N° 55.07

SUBJECT: STABILIZERS

Improvement of the flexible mounting of the stabilizer spar tube.

Corresponds to modification : AM 1300

(1) On installation :

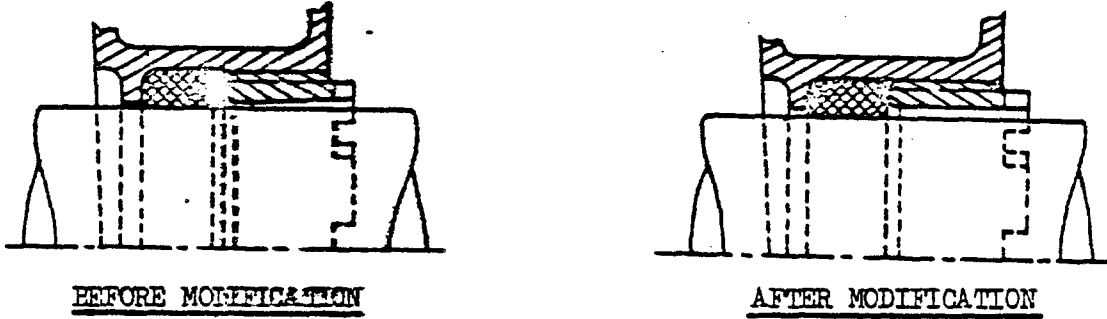
Install Teflon bushes 3160S.23.11.108 in the bracket housings. Fit castle nuts 3160S.23.107.

- . make sure that the bush is fully home in the housing,
- . make sure that the castle nut can be fitted freely, torque to 0.5 mdaN,
- . untighten the castle nut completely,
- . after drawing up against the bush, again apply a torque of 1.3 mdaN.

FIGURE 1

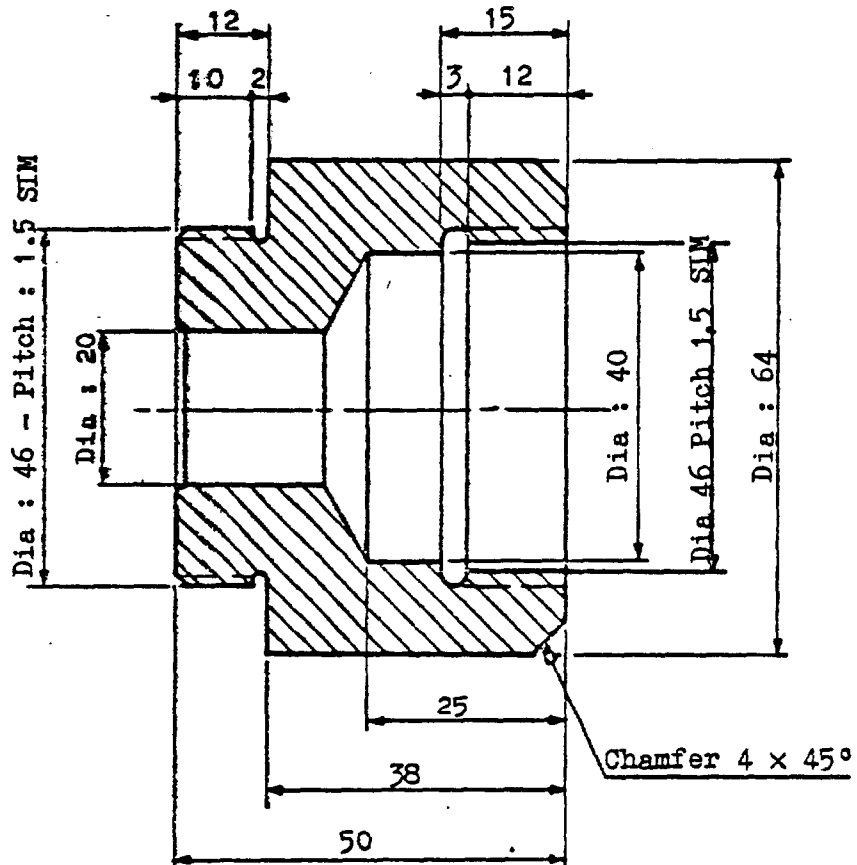
- (1) In accordance with the dimensions of figure 1, manufacture a tool out of steel (C.20 for instance), in order to be able to machine stabilizer brackets 3160S.23.11.092 and 3160S.23.11.093 and castle nuts 3160S.23.11.099 on a lathe.
- (2) Remove the stabilizer, in accordance with the instructions given in the Maintenance Manual, chapter 55.
- (3) Remove brackets 3160S.23.11.092 and 3160S.23.11.093 from the tail boom.

- On a precision lathe, use the tool manufactured according to figure 1 to modify brackets 3160S.23.11.092 into 3160S.23.11.105 and brackets 3160S.23.11.093 into 3160S.23.11.106, by reworking the inside diameter :

Material : C.20 steel, for exemple.

FIGURE 2

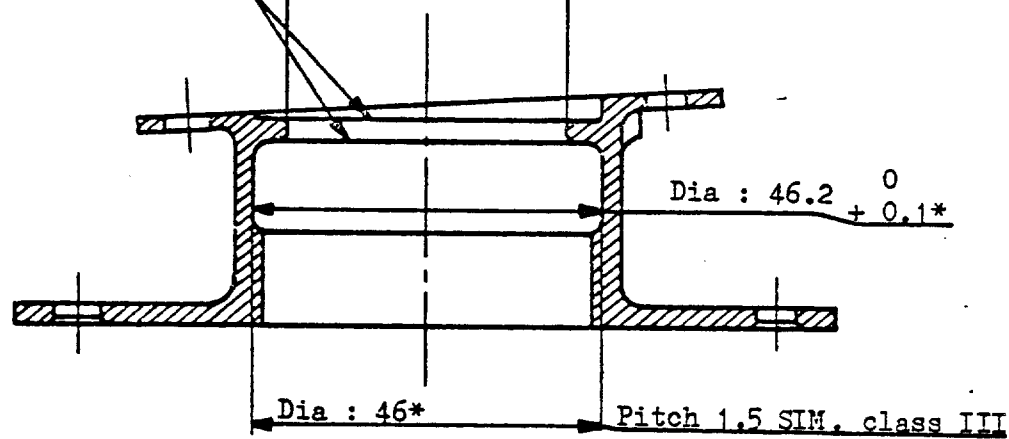
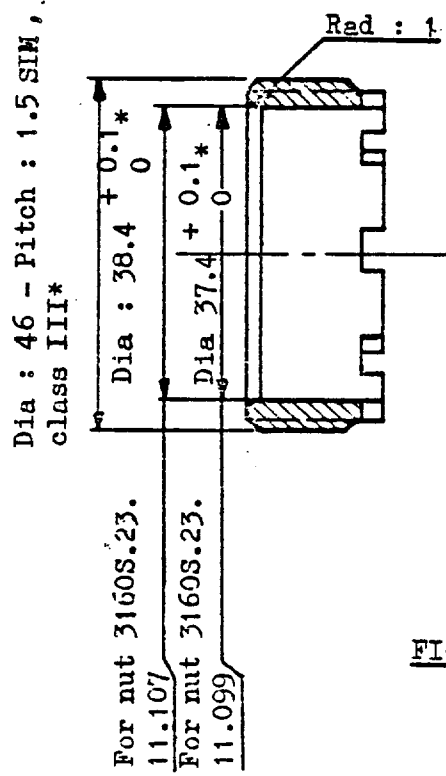
- (1) Transformation of brackets 3160S.23.11.092 and 3160S.23.11.093 into brackets 3160S.23.11.105 and 3160S.23.11.106.

dia. $37 \begin{smallmatrix} + 0.1 \\ 0 \end{smallmatrix}$ is machined to dia. $38 \begin{smallmatrix} + 0.1 \\ 0 \end{smallmatrix}$

radius 0.5 is machined to radius 1 mm.

- (2) Transformation of castle nuts 3160S.23.11.099 into castle nuts 3160S.23.11.107

dia. $37.4 \begin{smallmatrix} 0 \\ + 0.1 \end{smallmatrix}$ is machined to $38.4 \begin{smallmatrix} 0 \\ + 0.1 \end{smallmatrix}$

and by making a 1 mm radius.

Rad : 0.5 for brackets 3160S.23.11.092 and .093
 Rad : 1 for brackets 3160S.23.11.105 and .106

Dia : $38 \begin{smallmatrix} + 0.1 \\ 0 \end{smallmatrix}$ * for brackets 3160S.23.11.105 and .106
 Dia : $37 \begin{smallmatrix} + 0.1 \\ 0 \end{smallmatrix}$ * for brackets 3160S.23.11.092 and .093

NOTE : Diameters marked with an asterisk must be concentric within a tolerance of 0.05 (total indicator reading).
